TIBET ROAD  
(TRIBUTARY T TO E. 48TH AVE.)  
SITE PLAN FOR INFRASTRUCTURE  
TITLE:  
DATE: October 20, 2022

TIBET ROAD  
(TRIBUTARY T TO E. 48TH AVE.)  
SITE PLAN FOR INFRASTRUCTURE  
TITLE: LANDSCAPE DETAILS  
DATE: October 20, 2022

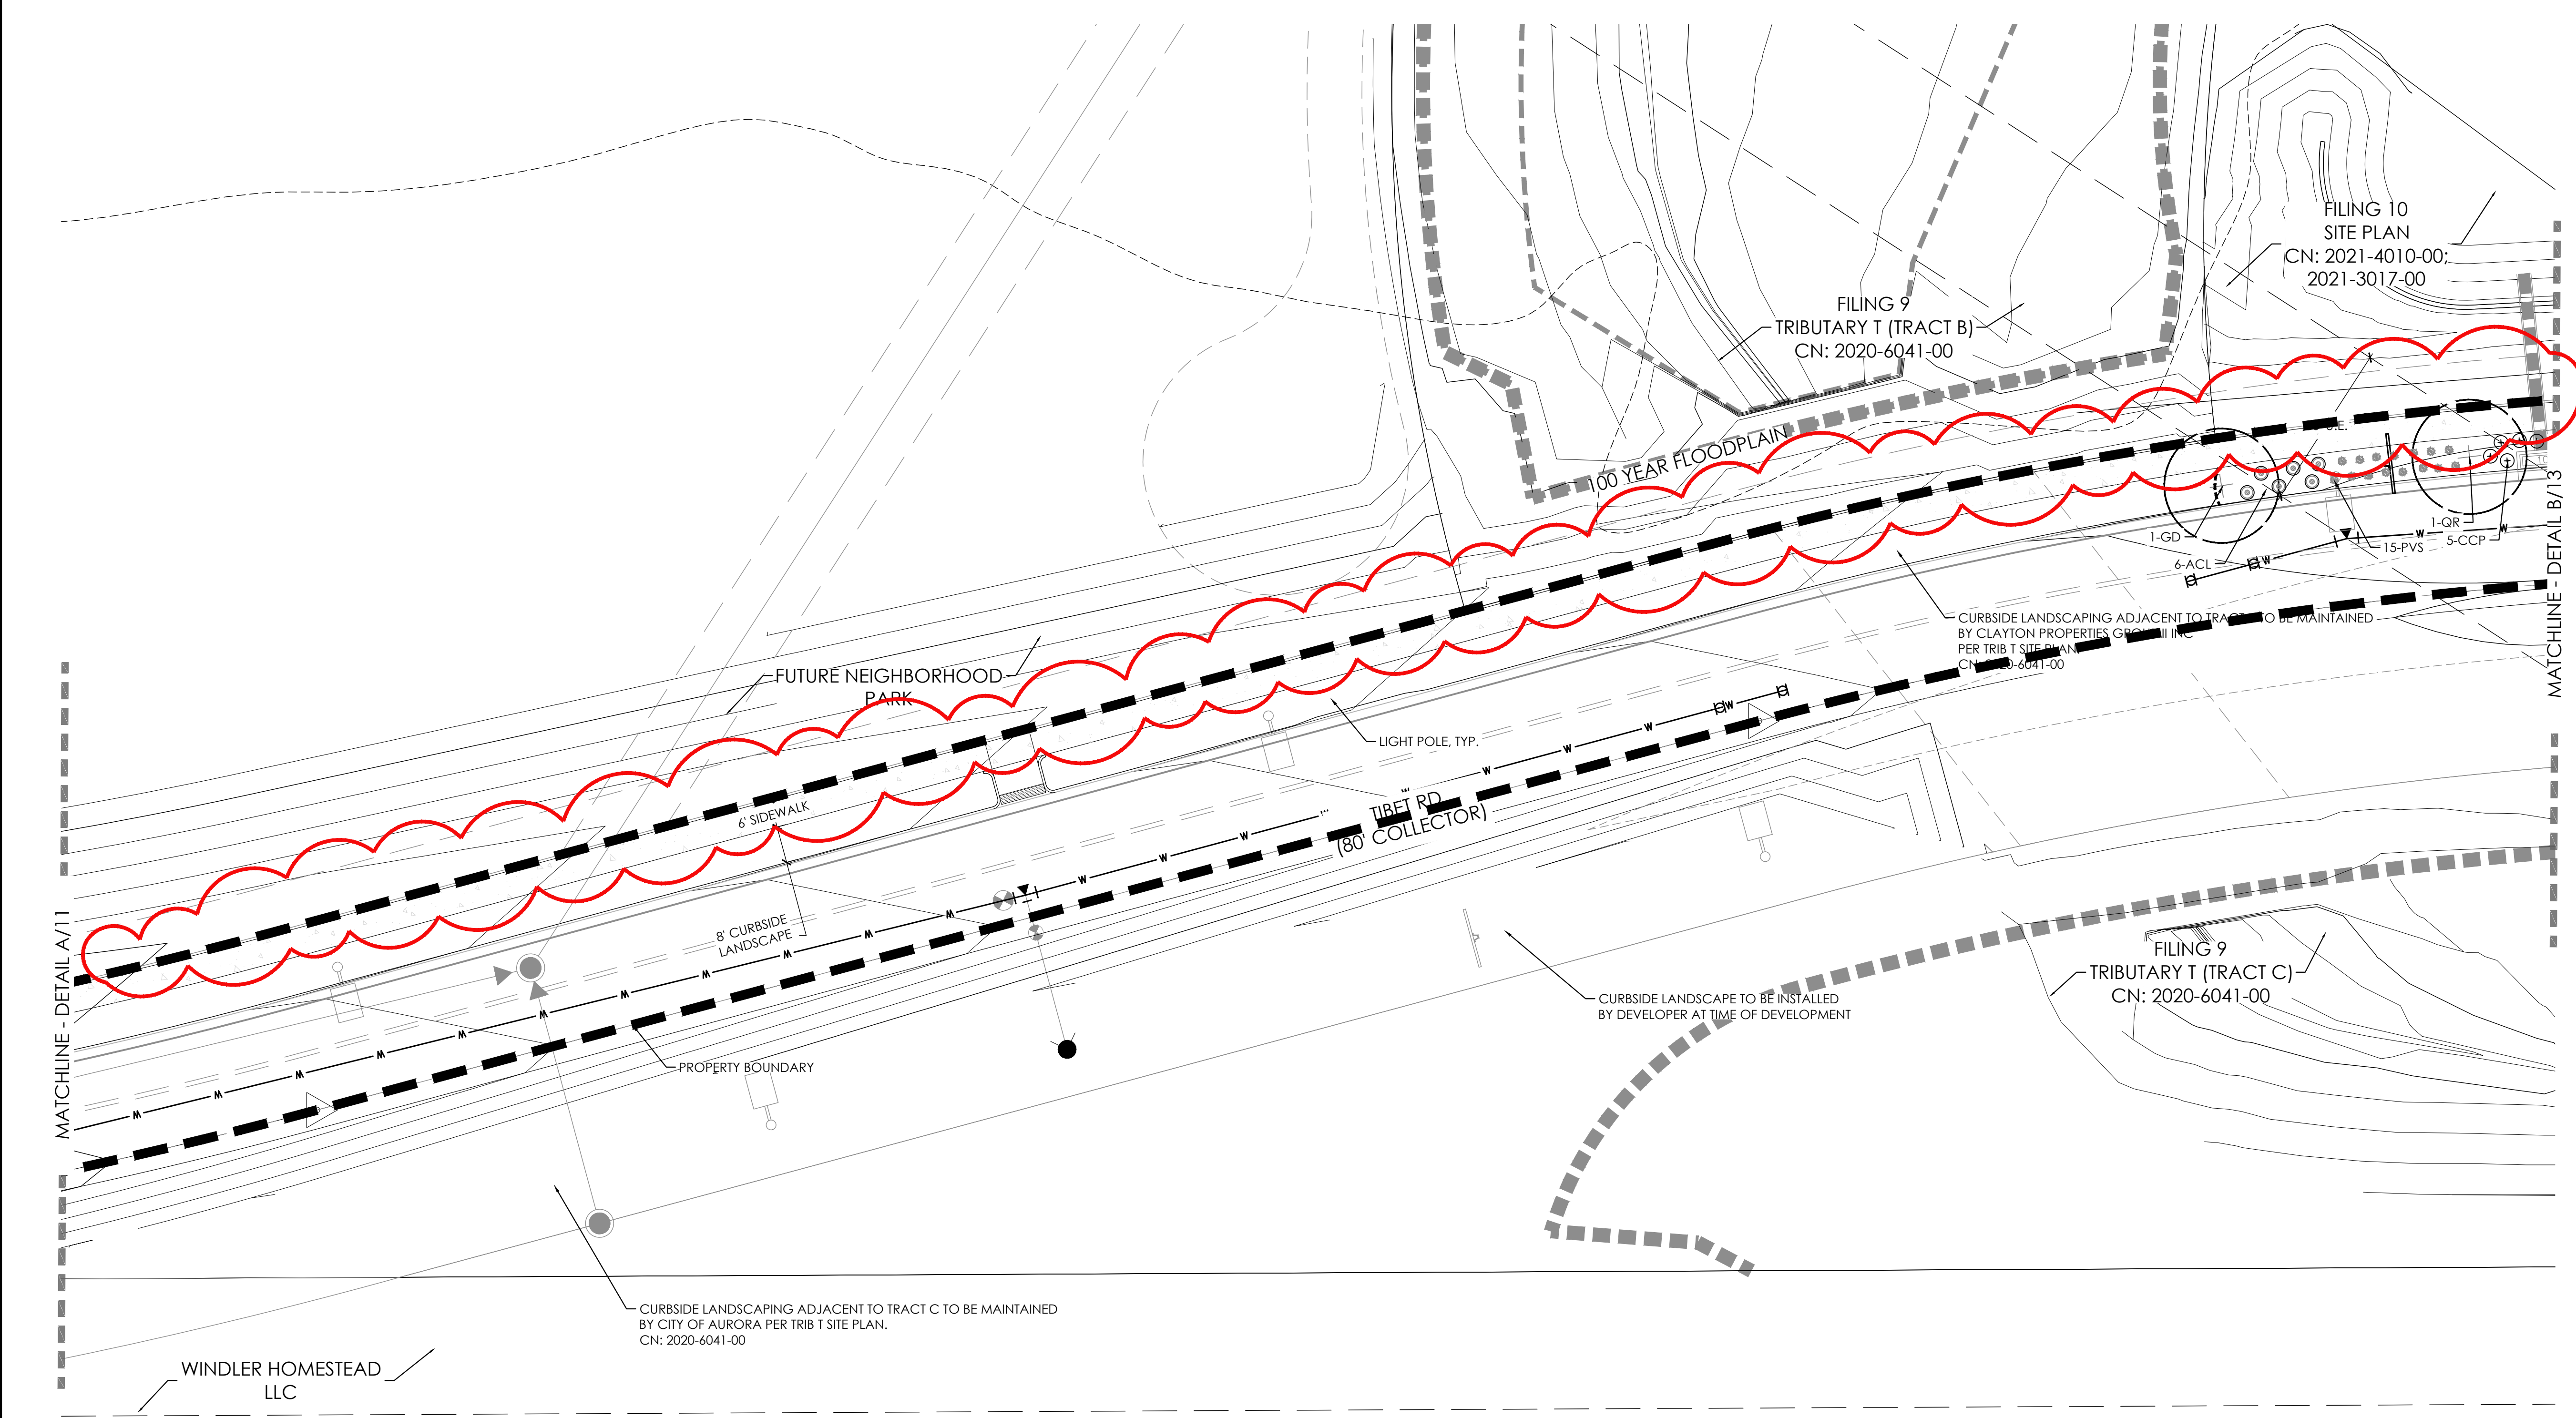
- REMOVE CRUSHER FINES BIKE PATH
- ADDED TURN LAND AND ROAD INTERSECTION INTO GVRE FILING 18
- PLANTING ADDED TO CURBSIDE
